CADIZ GROUNDWATER STORAGE AND DRY-YEAR SUPPLY PROGRAM

Final Environmental Impact Report
Final Environmental Impact Statement
Public Participation and Response to
Comments on the Draft EIR/EIS
Volume II
SCH. No. 99021039

FINAL ENVIRONMENTAL IMPACT REPORT FINAL ENVIRONMENTAL IMPACT STATEMENT CADIZ GROUNDWATER STORAGE AND DRY-YEAR SUPPLY PROGRAM SAN BERNARDINO COUNTY, CALIFORNIA

Figure
5

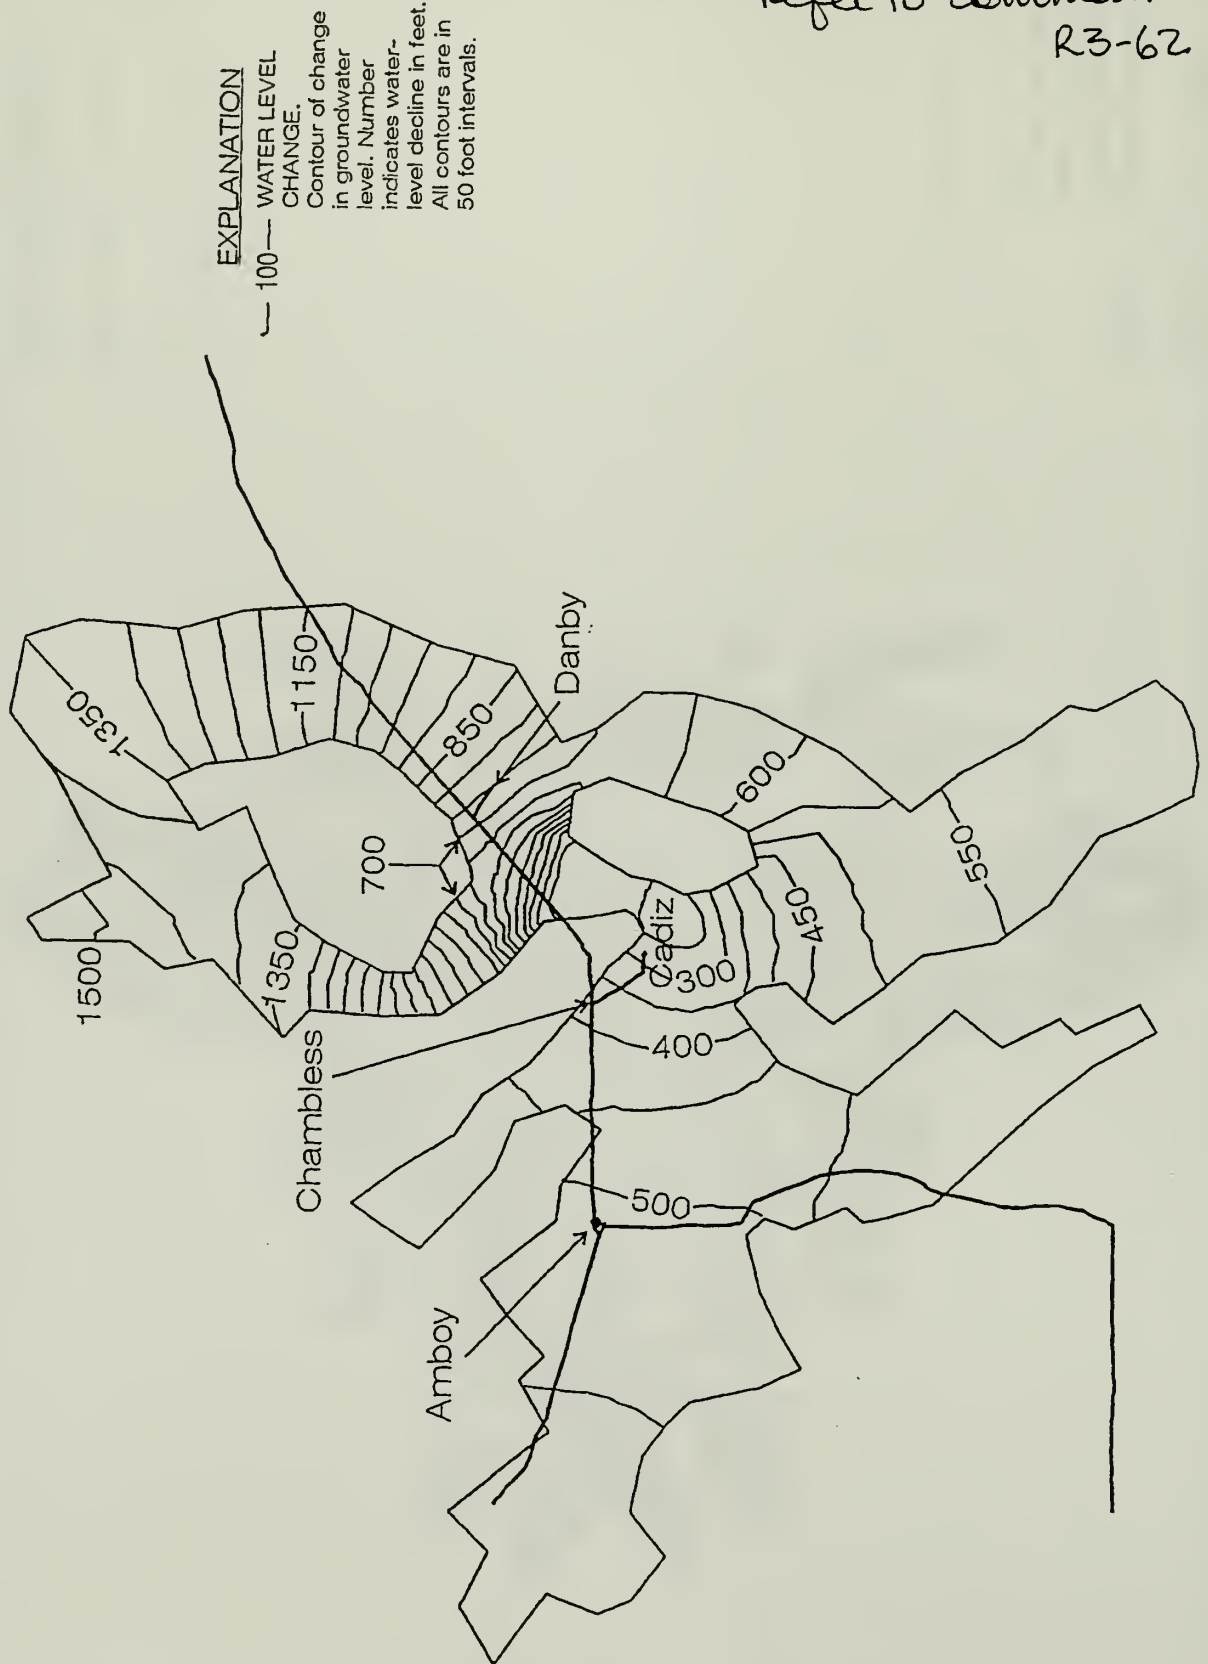
To demonstrate the inadequacy of the groundwater model developed by GeoScience (1999), I developed an alternative groundwater model. The groundwater model uses the computer program FEMFLOW3D (Durbin and Bond, 1998). The model is based on a mathematical formulation that allows an irregular geographic grid to represent a groundwater system. The grid for the Cadiz-Fenner Valley groundwater system is shown on Figure 4. Using a value of annual natural recharge of 5,000 acre-feet, the model was calibrated to fit groundwater levels listed by Moyle (1967), Koehler (1983), and Freiwald (1984). The resulting distribution of transmissivity is shown on Figure 5.

Refer to comment R3-62

Figure
7

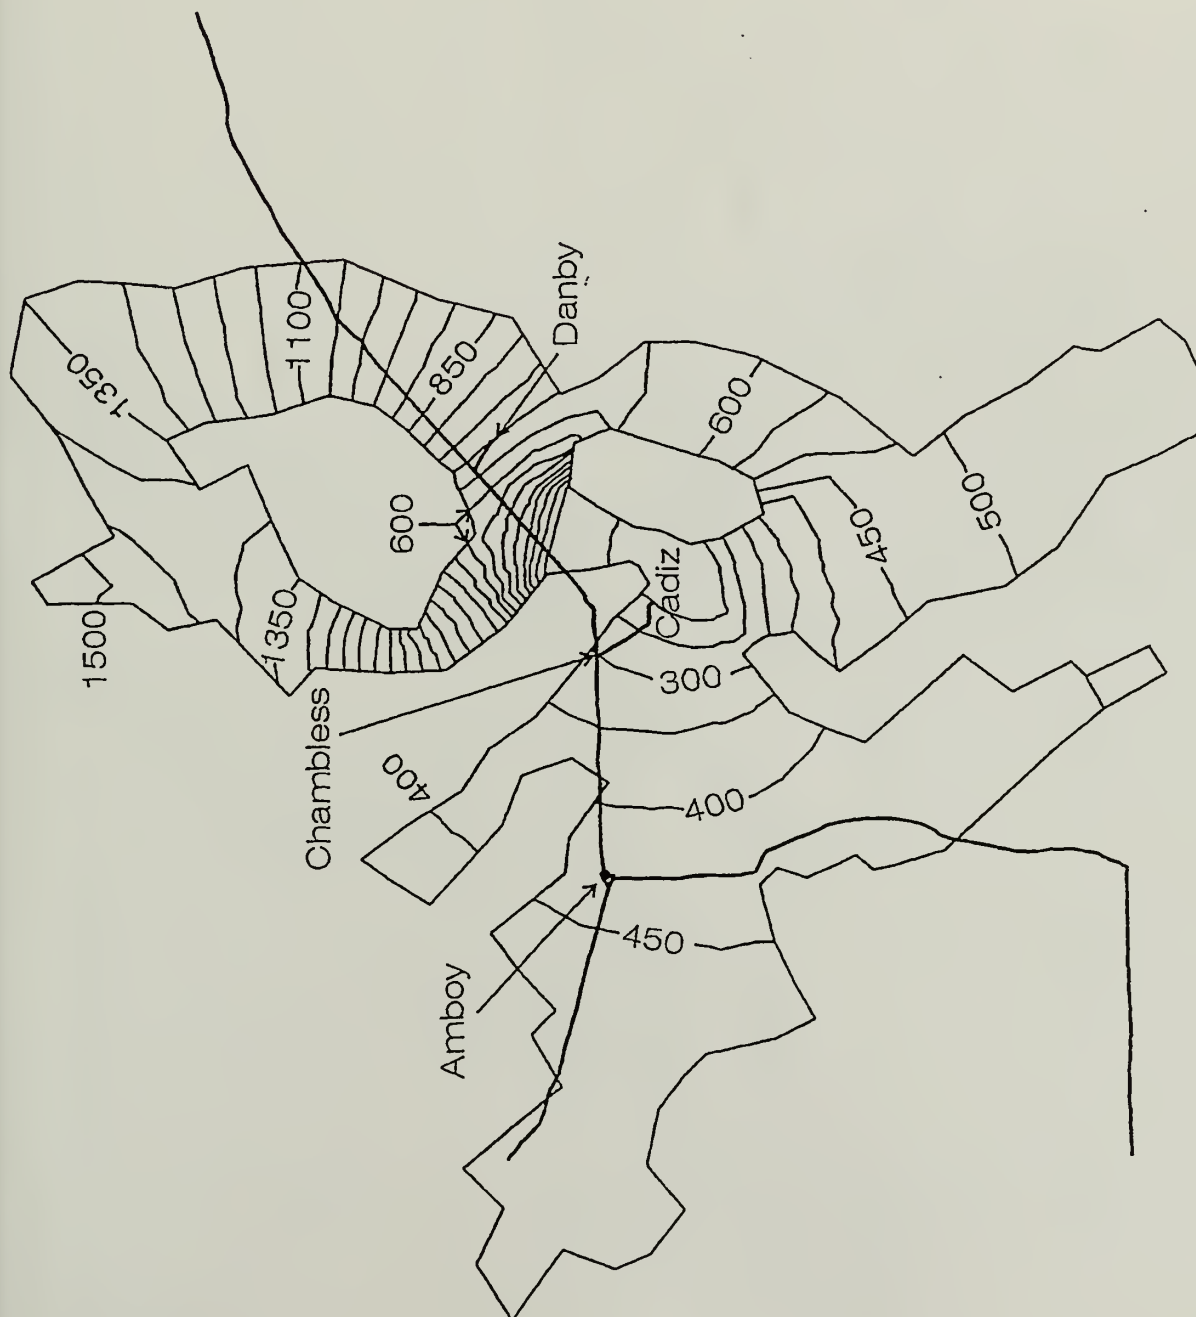
The Draft EIR/EIS indicates that the Project will produce only small impacts on groundwater levels over the 50-year project life. However, the alternative groundwater model indicates the opposite. Using the alternative groundwater model to simulate Scenario 6, the change in groundwater levels resulting from the implementation of the Project is shown on Figures 5 through 13. These maps and graphs indicate that large regional changes in groundwater levels will occur throughout Cadiz and Fenner Valleys as a result of the Project. These results completely contradict those reported in the Draft EIR/EIS (GeoScience, 1999). The Draft EIR/EIS states that the long-term change in regional groundwater levels will be less than 1 foot below Bristol Lake. If the groundwater model developed by GeoScience (1999) had been correctly conceptualized and calibrated, the simulation results from that model would have been like those produced by the alternative model. Because it was incompletely conceptualized and incorrectly calibrated, the model simulations produce a meaningless assessment of the expected project impacts. Accordingly, the model simulations cannot be relied upon.

Refer to comment
R3-62

CHANGE IN GROUNDWATER NEAR BRISTOL LAKE

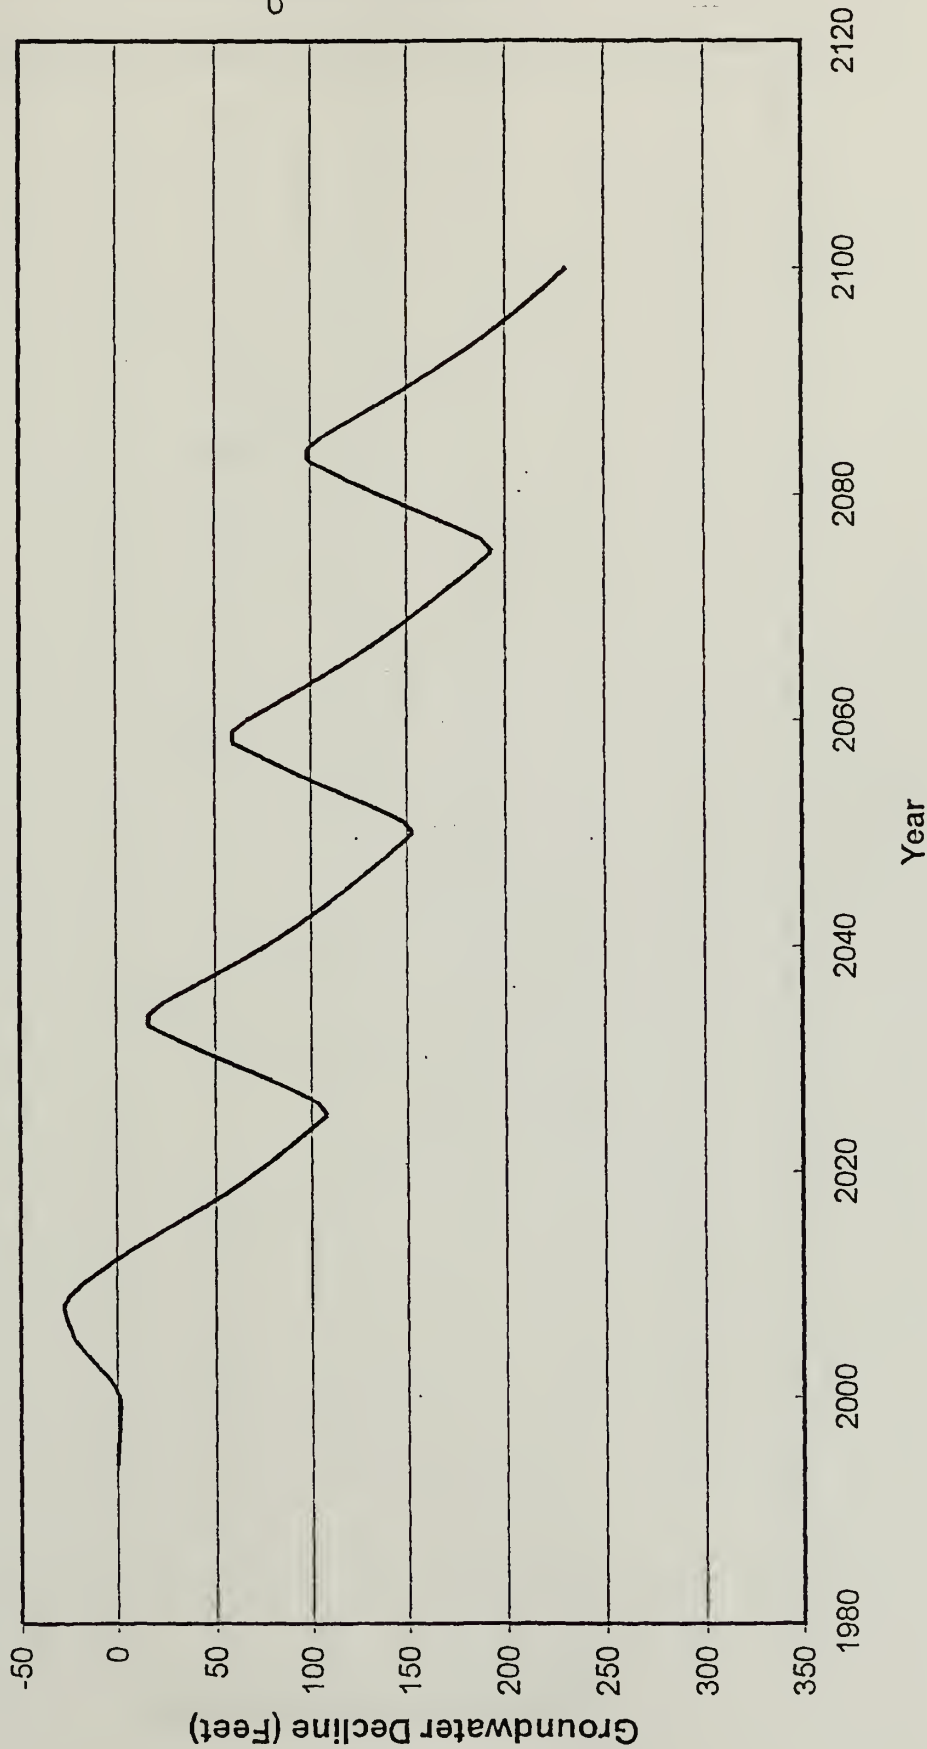
Refer to comment R3-62

CHANGE IN GROUNDWATER NEAR FENNER GAP

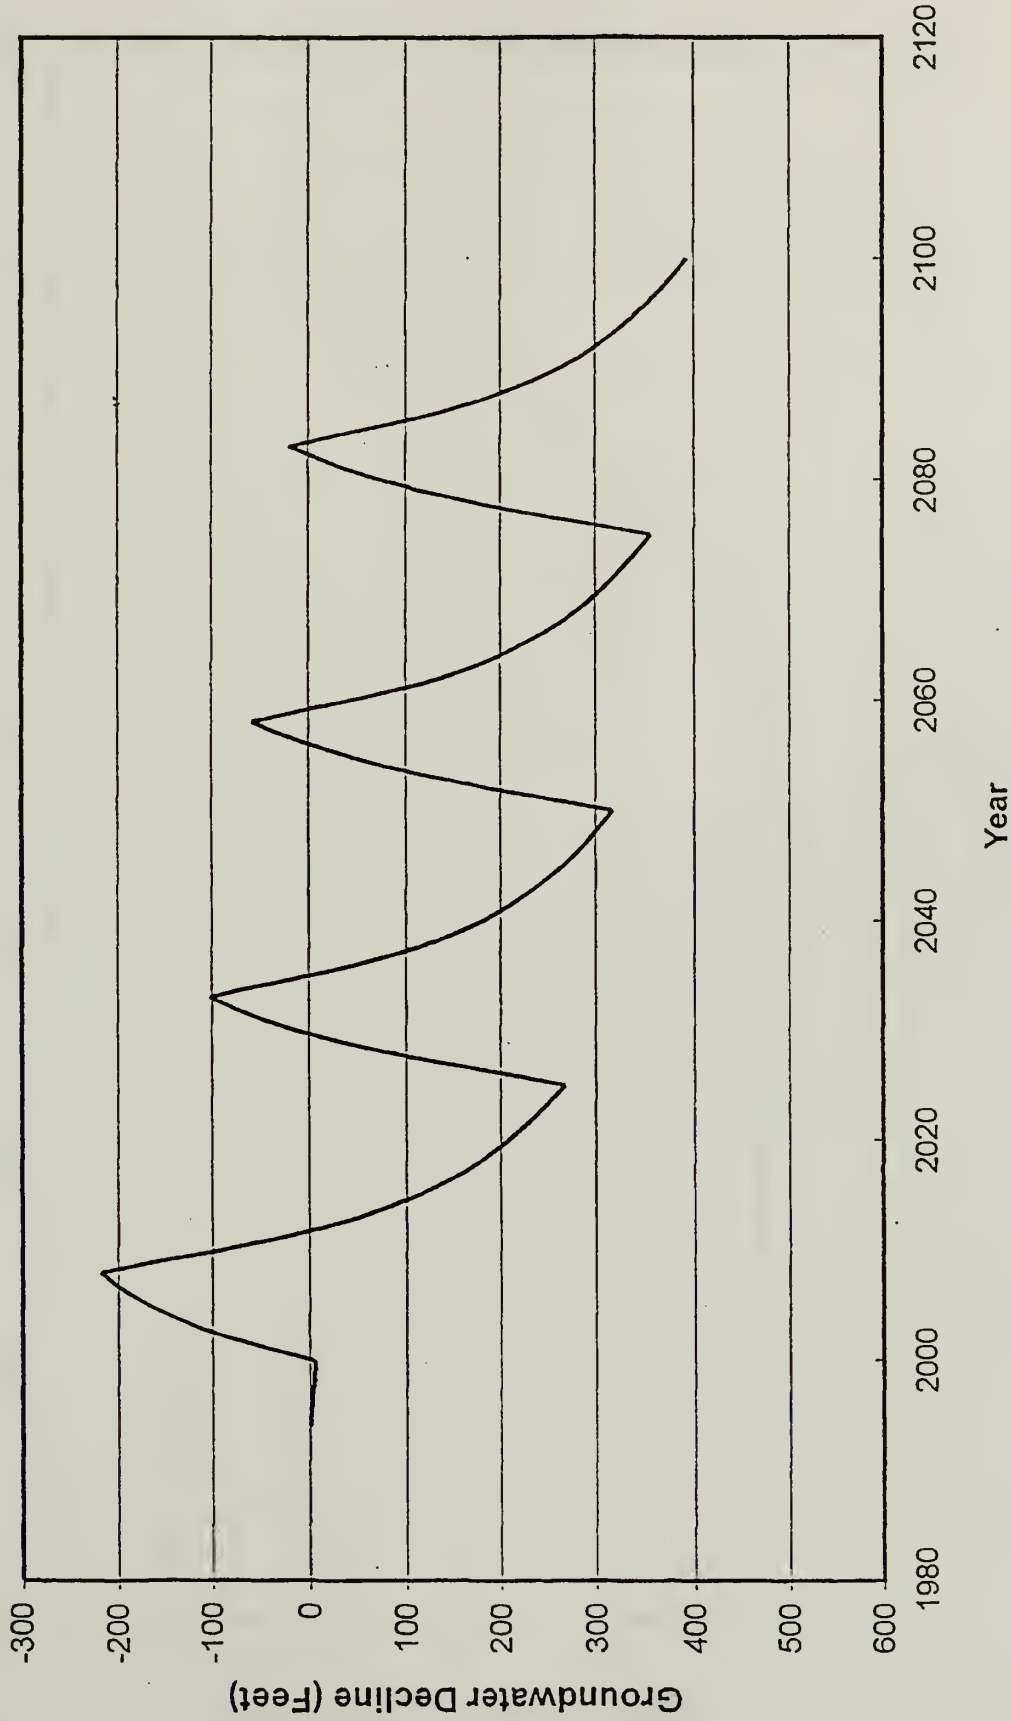
Refer to Comment R3-62

CHANGE IN GROUNDWATER NEAR UPPER END
OF FENNER VALLEY

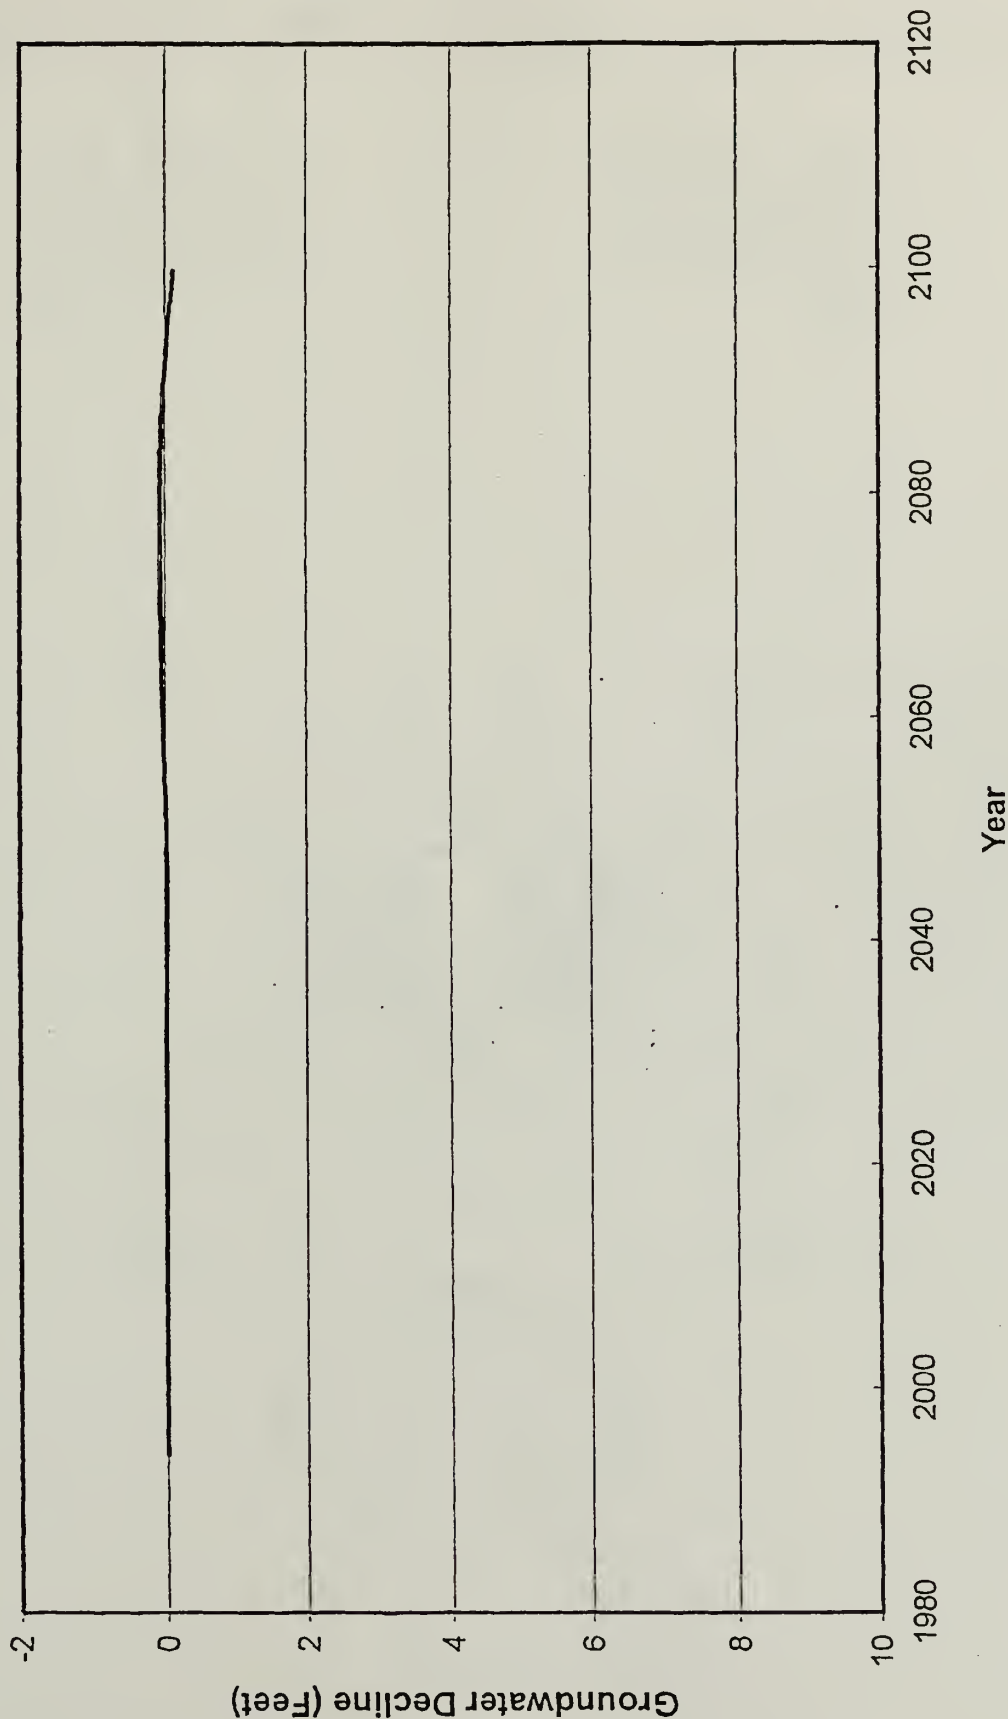
Refer to comment R3-6.2

Figure 15

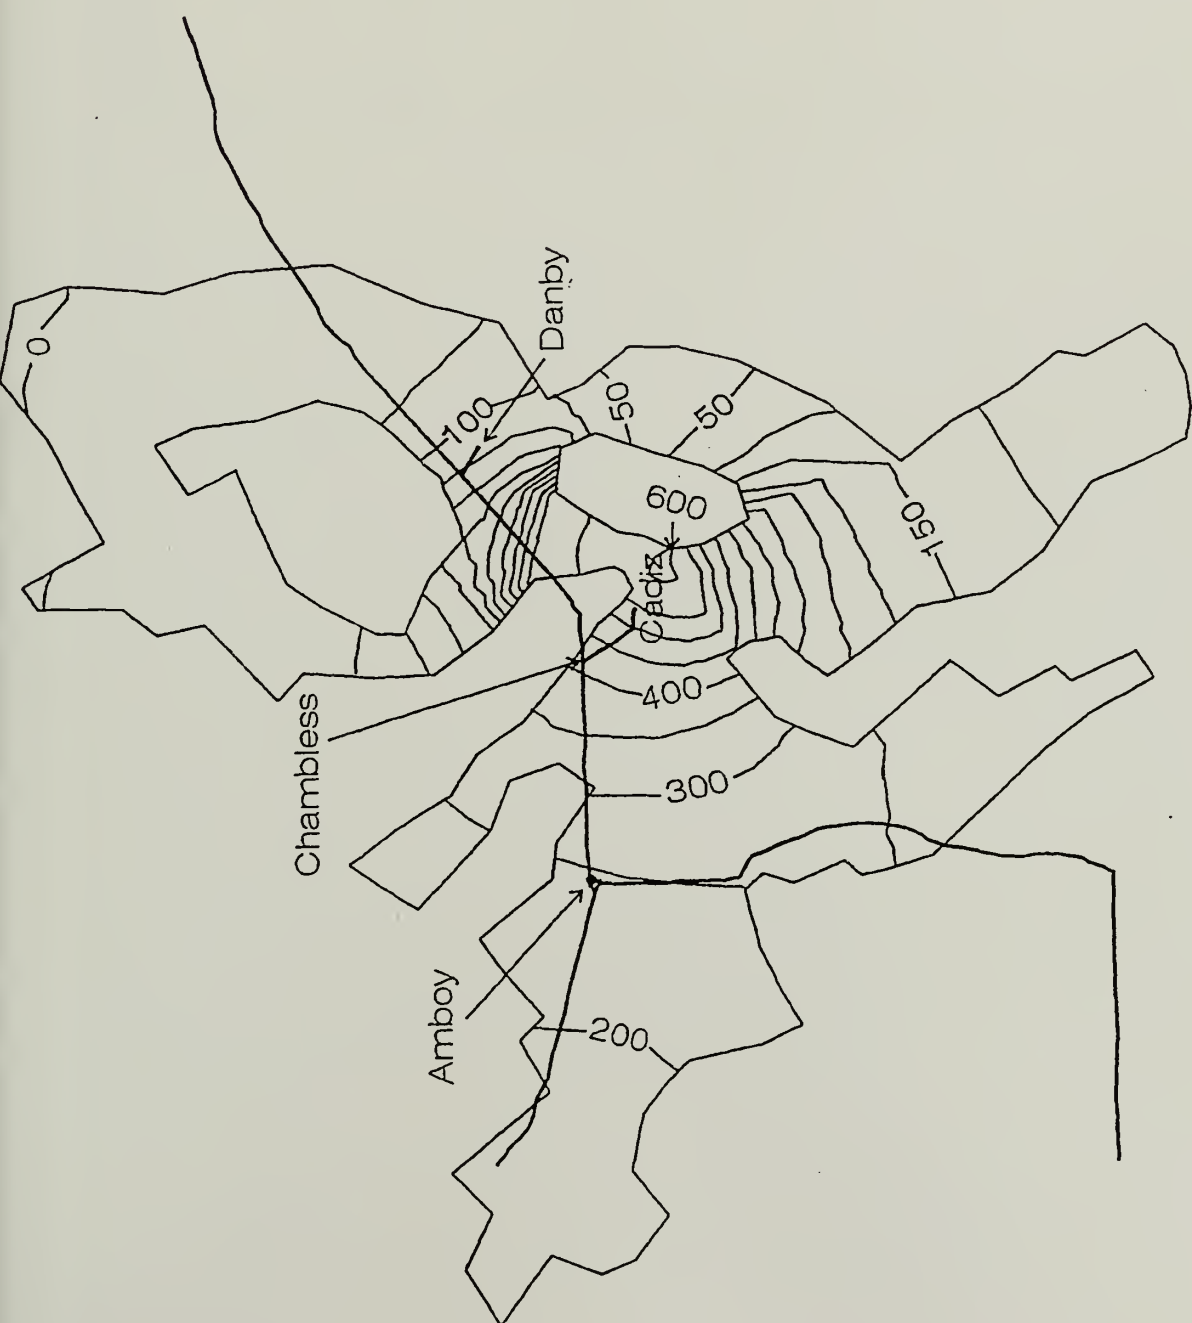
Refer to comment R3-65
